Access Compliance Report

Public Rights-of-Way

Intersection ID: 16385	Main Street: BEAM_RD	Cross Street: WESTOAK_DR	Location: E
ADA ID: 783F1DEC683B	Ramp Type: PerpDiag	Initial Pass/Fail: Pass	Overall Compliance: No
		Severity Score: 19

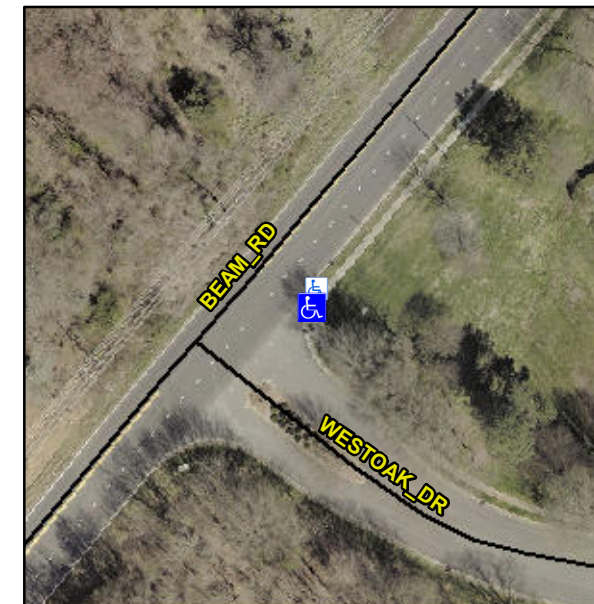
Not Found, R304.2.1, R305, R304.5.4

Compliance	Description	Data	Compliance	Description	Data
N/A	Ramp Length (in)	51.5	Yes	Ramp Slope (%)	6.2
Yes	Ramp Width (in)	48.0	Yes	Ramp XSlope (%)	1.3
N/A	Flare Type LT	Sloped	N/A	Flare Type RT	N/A
N/A	Flare Slope LT (%)	3.6	N/A	Flare Slope RT (%)	2.7
N/A	Flare Traversable LT?	Yes	N/A	Flare Traversable RT?	No
No	Landing Length (in)	45.0	No	DWS Provided?	No
No	Landing Width (in)	46.0	N/A	DWS Contrast?	No
Yes	Landing Slope (%)	0.2	N/A	DWS Length (in)	N/A
Yes	Landing X Slope (%)	0.3	N/A	DWS Full Width?	No
N/A	Landing Curb? (Y/N)	No	N/A	DWS Offset (in)	N/A
N/A	Shared Landing?	No			
Yes	Gutter Ponding?	No	No	Gutter Slope (%)	6.5
Yes	Gutter Lip Ht (in)	0.0	Yes	Gutter X Slope (%)	0.7
N/A	Painted X Walk1?	No	N/A	Painted X Walk2?	No
	X Walk 1 Direction	To NW		X Walk 2 Direction	To SW
N/A	X Walk 1 Width (in)	N/A	N/A	X Walk 2 Width (in)	N/A
	X Walk 1 Slope (%)	1.6		X Walk 2 Slope (%)	0.2
	X Walk 1 X Slope (%)	1.4		X Walk 2 X Slope (%)	1.6

Remove & Replace Curb Ramp With Two New Directional Ramps or Equivalent. Remove & Replace Gutter.
